**Amendments to the Drawings**

**REMARKS**

This Reply and Amendment is intended to be completely responsive to the Office Action dated May 5, 2005. Claims 1-34 are pending in this Application. Claims 12-14, 19, 22-24, 31-32 and 34 are currently withdrawn. Claims 1-11, 15-18, 20-21, 25-30 and 33 stand rejected. Claims 1-5, 8-11, 16-18, 20, 25, 27-28 and 30 have been amended. New FIGURE 3D has been added. The Specification has been amended to add new paragraph 0014.1 related to the addition of new FIGURE 3D.

FIGURE 3D

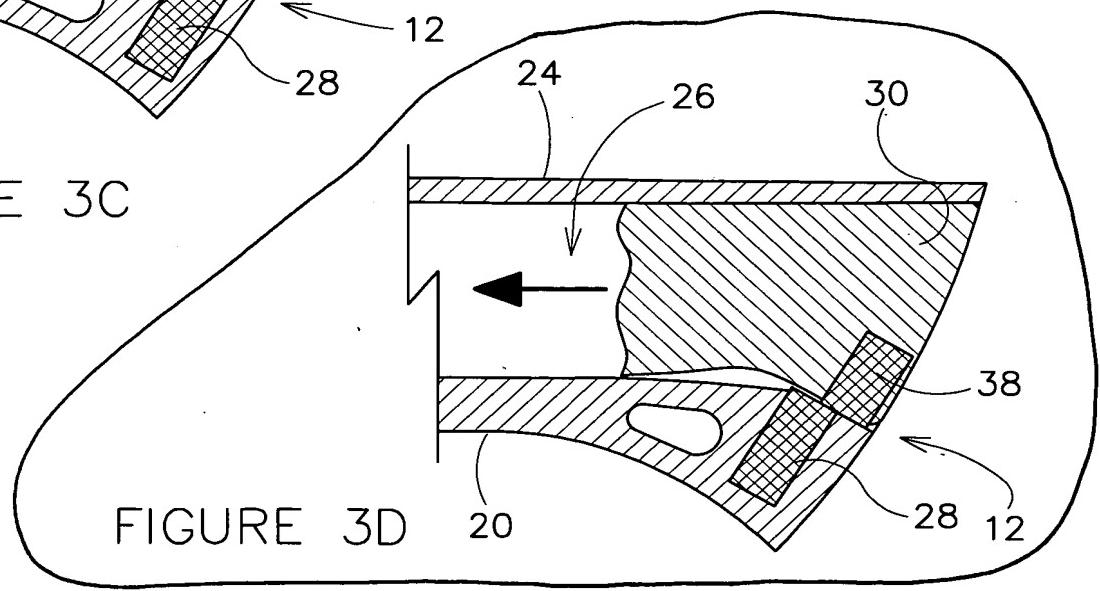
The drawing sheet 3/4 has been amended to add new FIGURE 3D, which shows one example of elements 28 and 38 to be arranged in an “offset” relationship. Appended to this Reply and Amendment is an annotated copy of the drawing sheet 3/4 which has been marked to show changes (i.e. the addition of new FIGURE 3D) presented in the replacement drawing sheet 3/4.

In Section 3 of the Office Action, the Examiner objected to the drawings because the “partially offset relationship” recited in Claim 18 must be shown or canceled from the claim.

The Applicants have added new FIGURE 3D which shows one example of a “partially offset relationship” and is supported by the Specification at (among others) paragraph 0021, lines 11-14.

The Applicants submit that new FIGURE 3D does not constitute new matter and properly addresses the objection under 37 C.F.R. § 1.83(a) to the drawings. The Applicants respectfully request withdrawal of the objection to the drawings.
